UNITED STATES PATENT AND TRADEMARK OFFICE

APPLICATION NO.	FILING DATE	FIRST NAMED INVENTOR	ATTORNEY DOCKET NO.	CONFIRMATION NO.
09/788,420	02/21/2001	Oh Nam Kwon	8733,388.00	5851
30827 7590 12/02/2011 MCKENNA LONG & ALDRIDGE LLP 1900 K STREET, NW WASHINGTON, DC 20006				
EXAMINER				
RUDE, TIMOTHY L				
ART UNIT		PAPER NUMBER		
2871				
MAIL DATE		DELIVERY MODE		
12/02/2011		PAPER

Office Action Summary**Application No.**

DETAILED ACTION

FIG. 1E
CONVENTIONAL ART

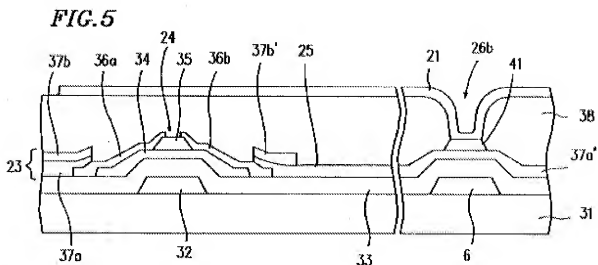
As to claims 1 and 8-9, APA discloses a liquid crystal display (LCD) device (Fig. 1E) having a substrate (10), a first conductive layer (12A with no 12B; 12B is optional per Applicant's specification, page 9, per amendment filed 08 May 2007) and a pad layer (14A) on the substrate, wherein the first conductive layer and the pad layer are patterned from the same conductive layer; a first insulating layer (16) on the substrate, the first conductive layer and the pad layer, the first insulating layer having a contact hole (above 14A) exposing a portion of the pad layer; (allowing electrical connection to 14A via contact hole above 14A);

a semiconductor layer (18) on the first insulating layer;
second conductive layers (20) on the semiconductor layer,
third conductive layers, (22A and 24A), on the second conductive layers,
a second insulating layer (26) on the third conductive layers, the second insulating layer having a first contact hole exposing a portion of the third conductive layers (contact hole for pixel electrode) and a second contact hole (hole for 30) exposing the portion of the pad layer through the first insulating layer,
a first adhesion conductive layer, 24B, on the exposed portion of a third conductive layer and a second adhesion conductive layer, 14B, on the exposed portion of the pad layer, wherein the first adhesion conductive layer is directly contacted with the third conductive layer and the second adhesion conductive layer is directly contacted with the pad layer [per APA Figure 1E];
a fourth conductive layer (28) on the second insulating layer and the first adhesion conductive layer and electrically contacting a portion of a third conductive layer;

a fifth conductive layer (30) on the second insulating layer and the second adhesion conductive layer and electrically contacting the pad layer.

Please note, this is a device claim whereby "formed in" is considered to limit where structure is as opposed to how it got there. Also, something that is at the bottom of a hole is reasonably considered to be in the hole.

APA does not explicitly disclose an embodiment wherein the first and second adhesion conductive layers are respectively contained within the first contact hole and in the second contact hole.

Tagusa teaches at Figure 5 an embodiment wherein such a metal layer, 41, may be deposited [Applicant's "plated"] such that it is exclusively and entirely contained within the contact hole, 26b

Therefore, it would have been obvious to one having ordinary skill in the art at the time the invention was made to modify the reflective display invention of APA with the sixth metal layer(s) formed [Applicant's "plated"] such that it is exclusively and entirely contained at the bottom of all contact holes

as an art recognized configuration suitable for the intended purpose of improving adhesion of the overlying conductive layer with the underlying conductive layer [col. 12, lines 4-34] which would improve yield and reliability [MPEP 2144.07]. This would result in a change of configuration from that shown in Applicant's Figure 1E (elements 12A and 14A) to Applicant's Figure 3E (to corresponding elements 34 and 36).
